## **URGENT MEDICAL DEVICE CORRECTION (NOTIFICATION)**

### **Update to Instructions for Use US Customer Letter**

Impella Product Code	Impella Product Description	UDI-DI
0046-0035	Impella RP® with SmartAssist®	00813502011869
1000323	Impella RP Flex™ with SmartAssist®	00813502012811

Figure 3: Cautions in RP Flex IFU 10003286 revision H and RP with SmartAssist IFU 0052-9013 revision H

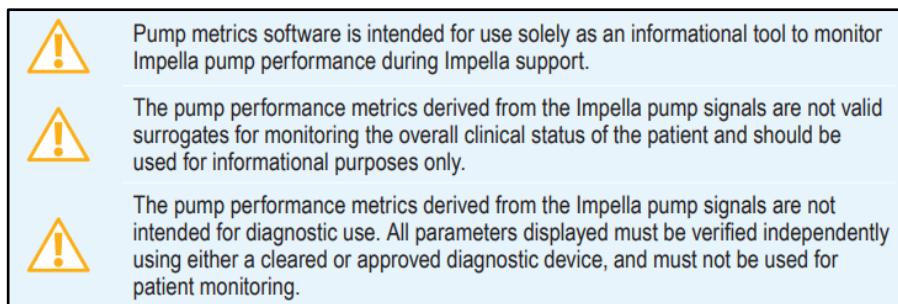
As per the IFU Cautions in Figure 3 (below), clinicians should continue to: monitor patient hemodynamics with approved diagnostic devices, verify Impella positioning with imaging, and refer to the P-level flow rates listed in the Instructions for Use (IFUs), as shown in Figure 1 in this letter. These

values reflect the flow rate range of the pump on defined pressure gradients under controlled conditions; actual pump flow depends on preload, afterload, and can vary due to suction, incorrect positioning, or presence of thrombus in the inlet.

Displayed flow and metrics may be inaccurate due to differential pressure sensor drift. Sensor accuracy can also be affected by physical contact including handling during insertion, presence of thrombus in the inlet, contact with concomitant lines or devices, or contact with patient anatomy. Table 5.4 P-Level Flow Rates should be relied on over the AIC displayed flow. Clinicians should continue to use pump metrics to monitor Impella pump performance, monitor patient hemodynamics using cleared or approved diagnostic devices, and monitor Impella positioning with imaging. An abrupt change in flow or abrupt discrepancy from the IFU may indicate a need to reassess pump positioning and performance, patient conditions, and clinical hemodynamics.
